# UNITED STATES PATENT AND TRADEMARK OFFICE

APPLICATION NO.	FILING DATE	FIRST NAMED INVENTOR	ATTORNEY DOCKET NO.	CONFIRMATION NO.
10/729,466	12/06/2003	William Loo	P18477US1	1261
7590 05/04/2007				
Alex Nicolaescu 8400 Decarie Bld, QA3096 Montreal, QC H4P 2N2 CANADA				
		EXAMINER		
		MOUZON, LAJUANIA N		
		ART UNIT	PAPER NUMBER	
		2109		
		MAIL DATE	DELIVERY MODE	
		05/04/2007	PAPER

## Office Action Summary

## **DETAILED ACTION**

*fig. 2*

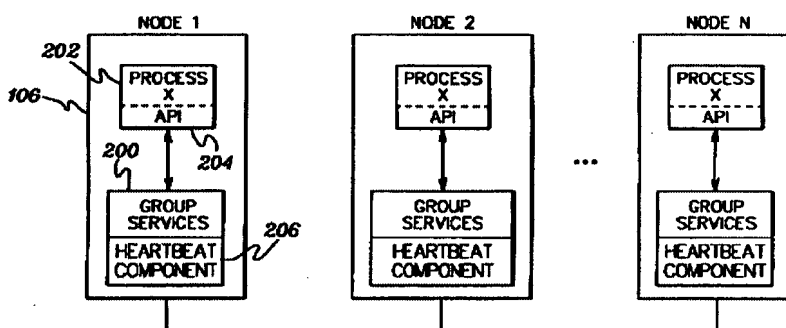
37. In regards to claims 9 and 17 neither Khan et al. nor Morgan et al. teach, wherein step a. is performed by the second processing node using a heartbeat mechanism with the first processing node.

38. In the same field of endeavor Badovinatx et al. teach the second node using a heartbeat mechanism to determine if it is still available (**Fig 2 and Col. 3 line(s) 62-64.**).
